Addendum 2
Invitation to Bid 15110
Construction of Rural Power Plant Upgrades
On behalf of the City of Nunam Iqua

Addendum 2 extends the bid date, replaces the original bid schedule, and answer questions.

STATE OF ALASKA, AIDEA/AEA
RURAL POWER SYSTEM UPGRADE
 NUNAM IQUA POWER PLANT
 NUNAM IQUA, ALASKA

DRAWING TITLE:
MODULE AND CATWALK BEAM LAYOUT PLAN

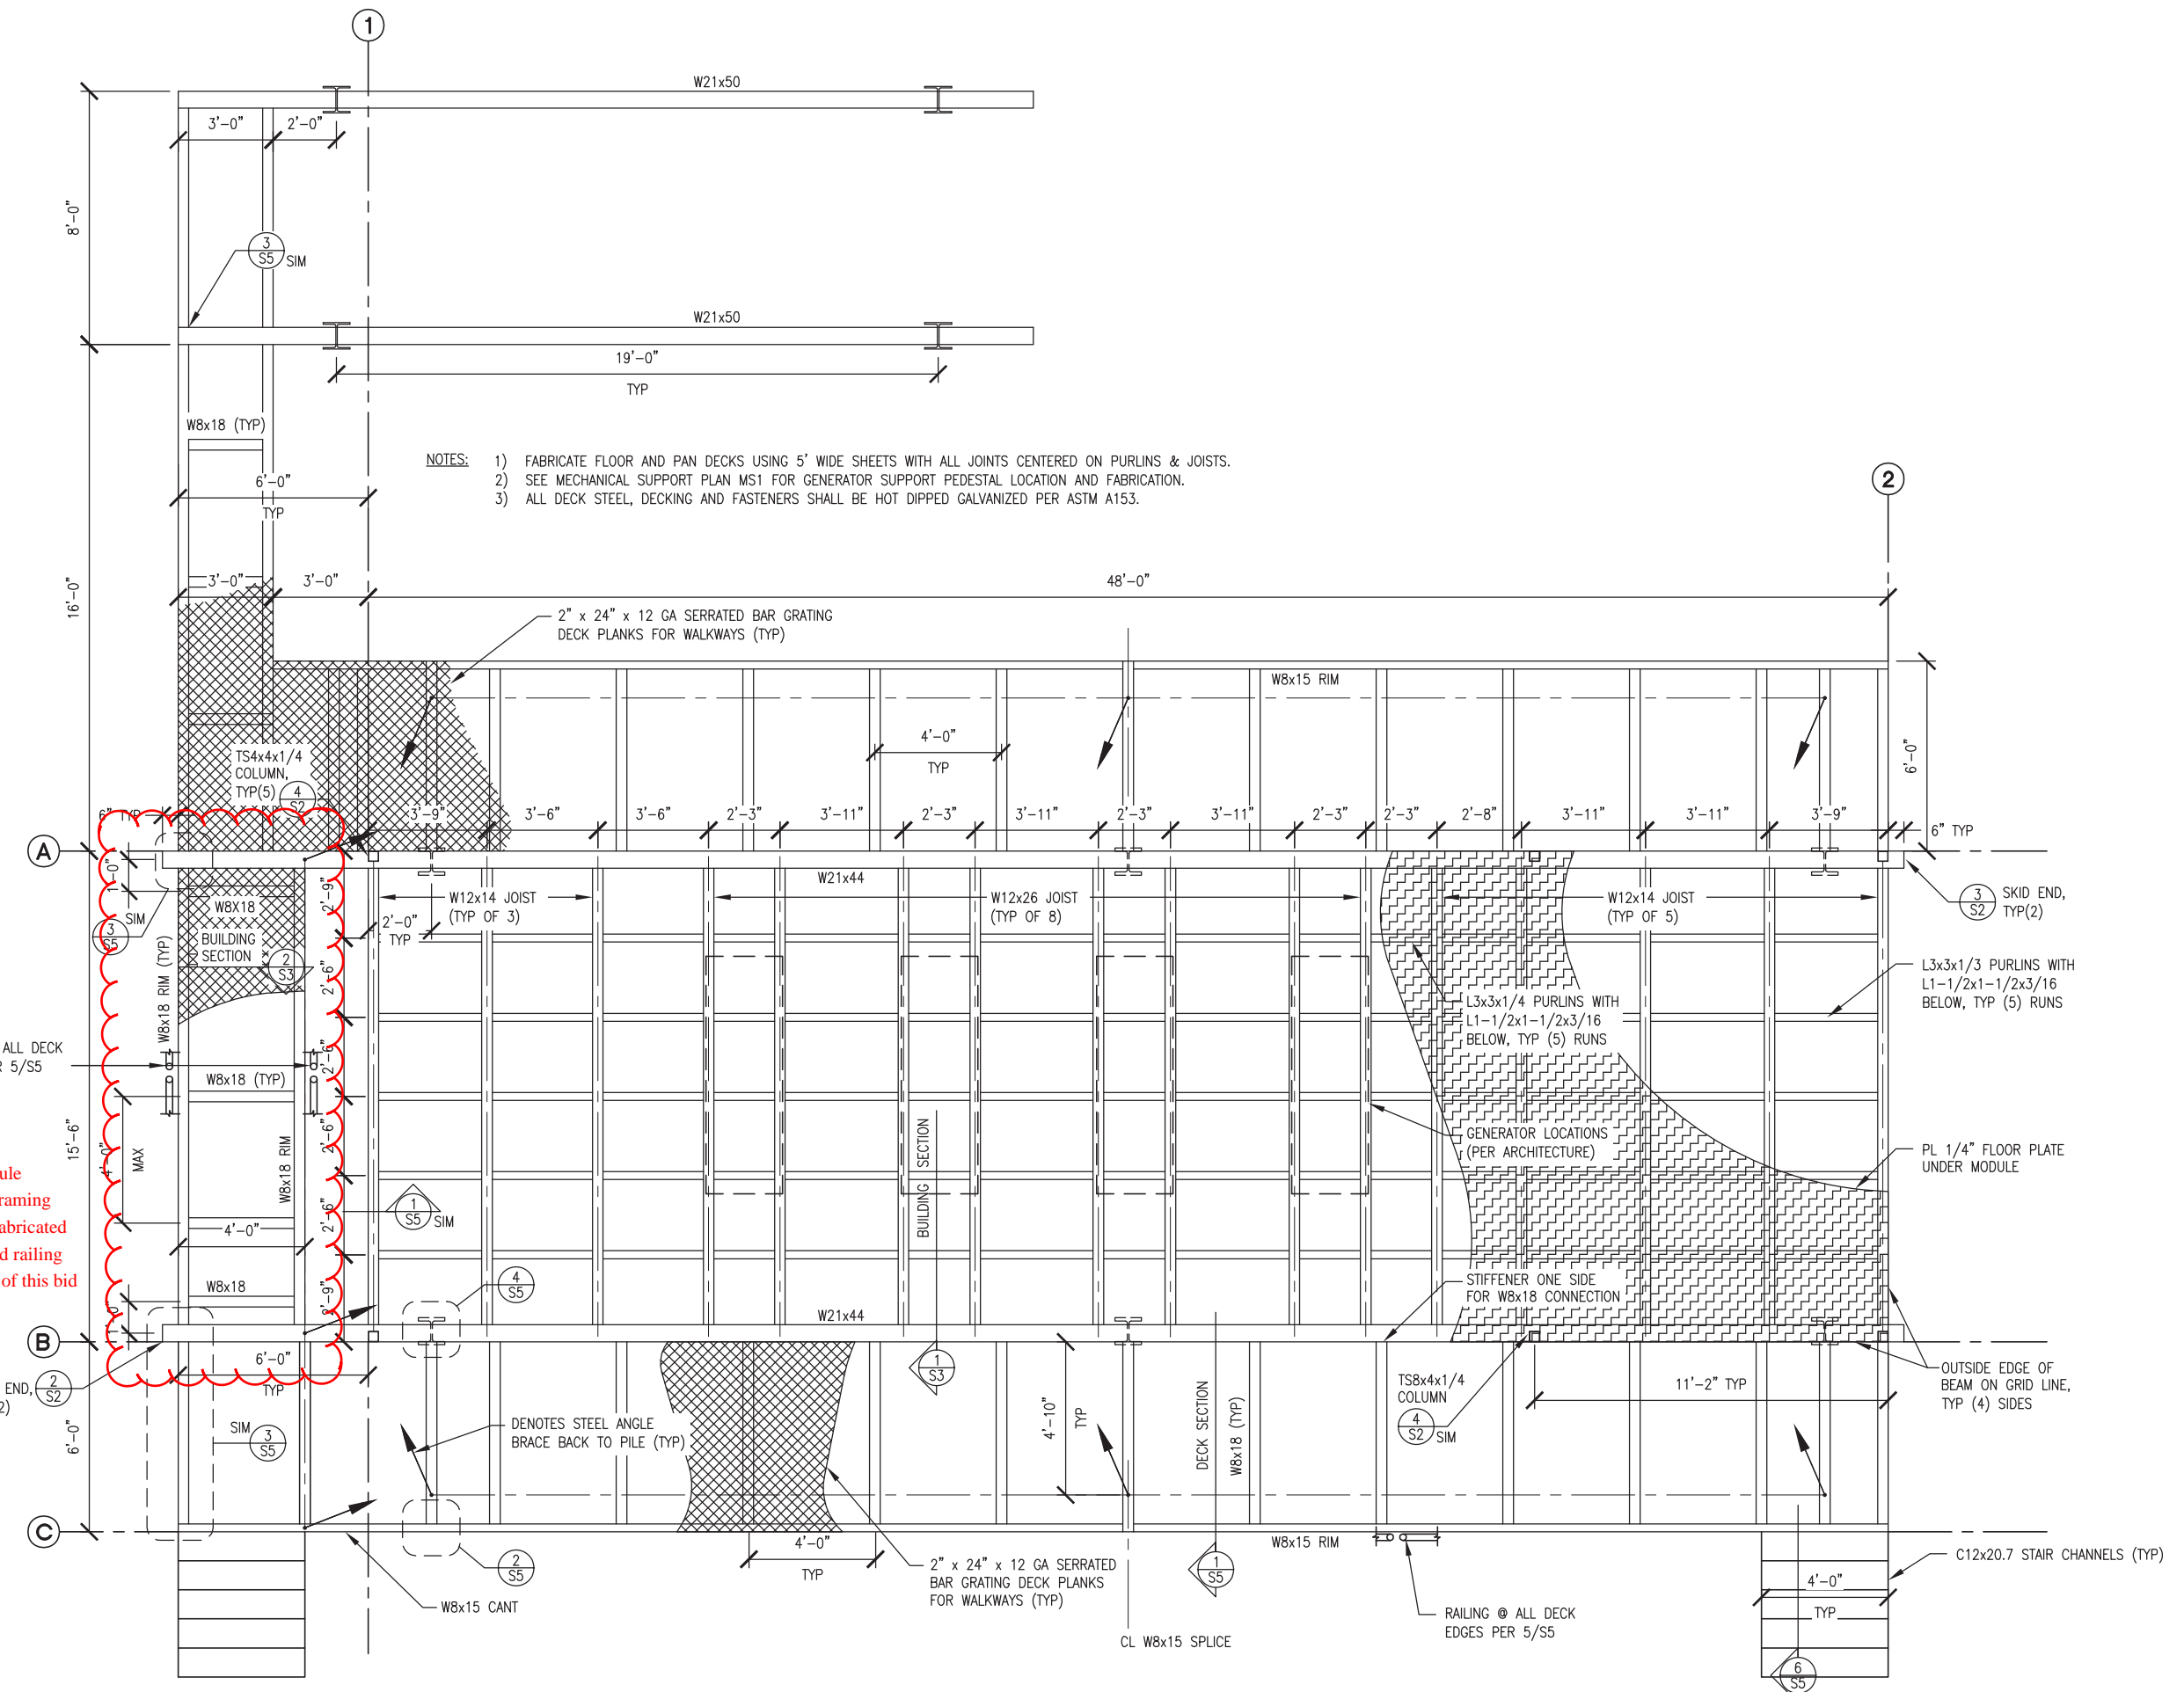
1. **The Bid Submission date is extended.** Bidders shall submit sealed bids in single (1) copy. All Bids including any modifications or withdrawals shall be received prior to the bid opening; bids will be publically opened at Authority's Office on **Tuesday, March 3, 2015 at 2:00 p.m.** Alaska time, Willow Conference Room.
2. Please acknowledge receipt of this addenda on the Bid Schedule herein.
3. Sheet S1.2 refers to detail # 1/S3, 2/S3, and 4/S2. I do not see sheets S2 or S3 in the bid doc plans.

5. The specs call for all the deck steel to be HDG (note 3, Sheet S1.2). This essentially eliminates any pre-fabrication in Alaska. Would it be possible to have a deviation to zinc coat, or other method?

6. Note # 2 on sheet S1.2 states "See Mechanical Support Plan MS1..." MS1 is missing from the bid set.

13. Replace Sheet S1.2 with attached revised Sheet S1.2. Shows wide flange deck framing located between the extended module skid beams will be provided with the module and are no longer in scope.

16. Section 00800 Add SC 8 -Insurance Requirements, additional (Section 5.4.2 e. of the General Conditions), Contractor shall provide Marine Cargo Carriage Insurance for the full value of the module in transport estimated at a value of \$1.5-million.
17. Confirm use of Welded Bar Grating vs Grip Strut Plank Grating.

Answer: All grating is to be Serrated Bar Grating as called out on S1.2. There is no Grip Strut in this project.

Answer: Delete references to detail 1/S3, 2/S3 and 4/S2.

Answer: Provide HDG as per specification. No deviation allowed.

Answer: Delete reference to MS1.

Wide Flange framing between module skids will be provided by others. Framing connections and beams have been fabricated by module supplier. Bar grating and railing to be supplied by contractor as part of this bid

1 ROAD CROSSING DETAIL
C6.8 NTS

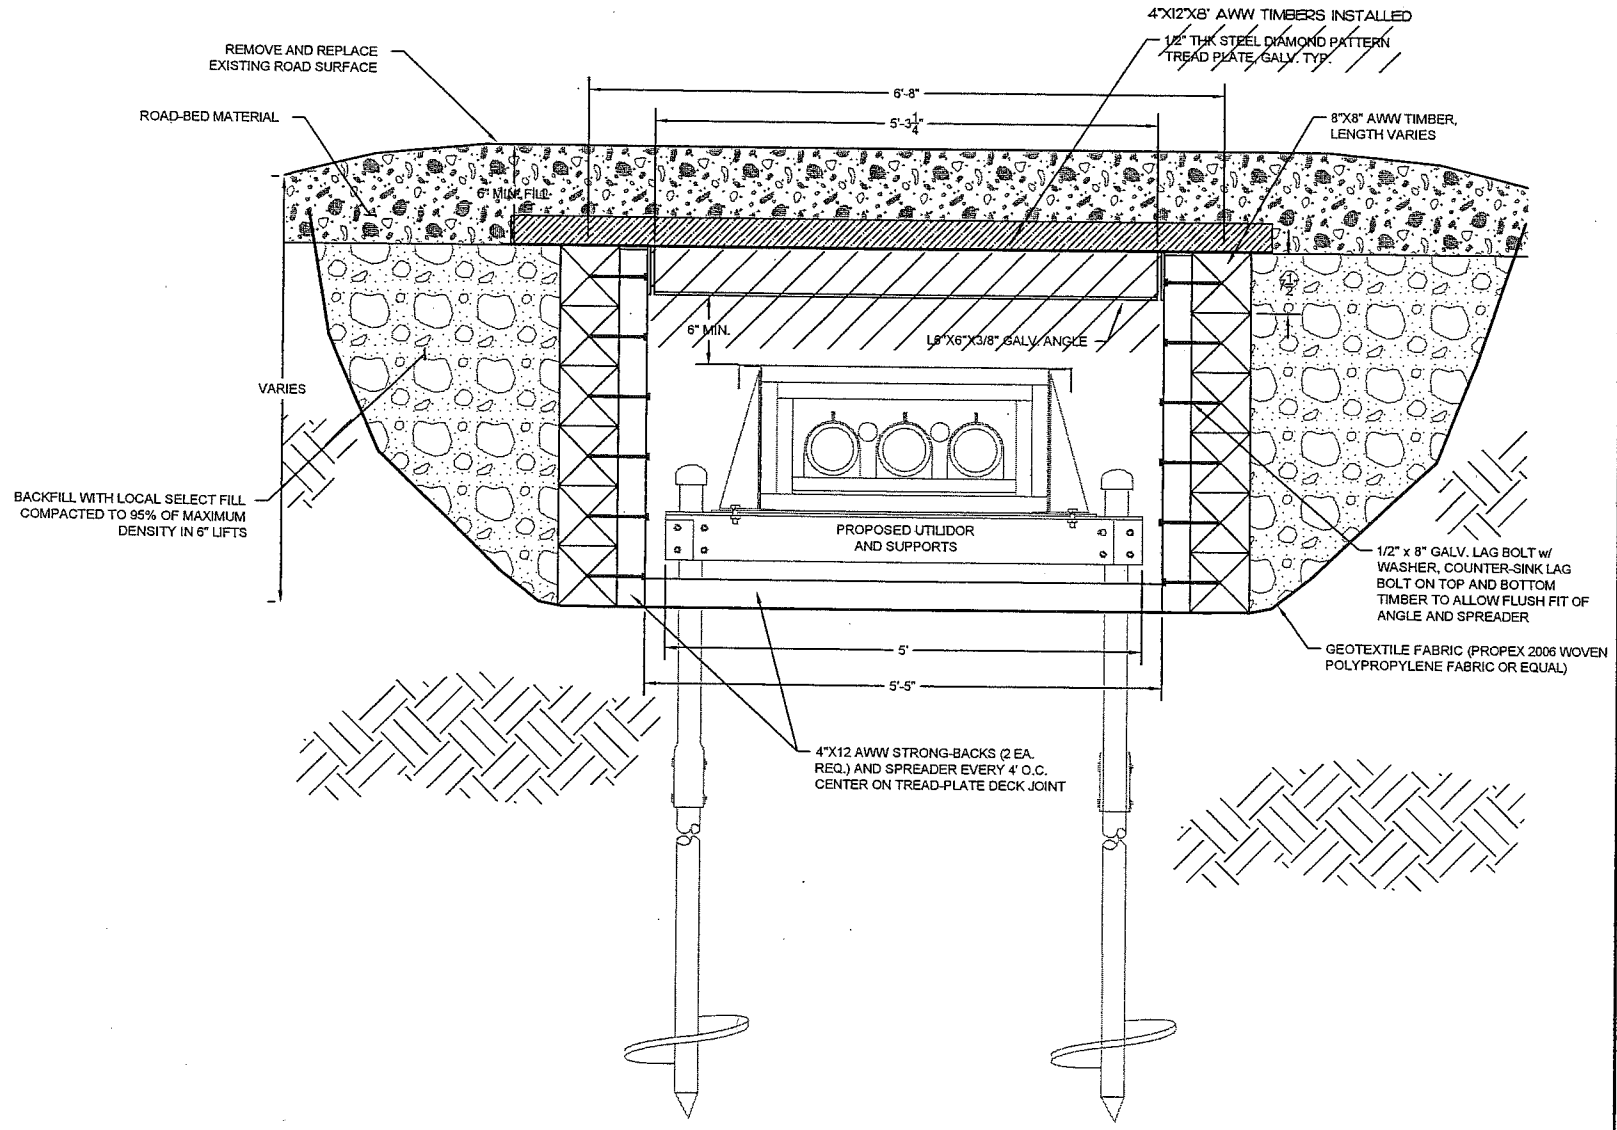
4. Sheet C2 shows a possible underground utility crossing west of the city hotel and tribal office. In today's pre-bid, it was mentioned we would not need to cross, but I believe Joe was referring to the crossing to the east of the City Hotel. Looking on Google Earth, it also appears there is a major crossing here. Can you confirm the depth of this utility crossing?

Answer: Attached CE2 as-built record drawing sheet C6.8 is included for reference. City personnel note that Cat D8 and D9, and loaded dump trucks have used the crossing in the past without issue. Bidder shall be responsible to ensure project equipment does not damage utilidor(s).
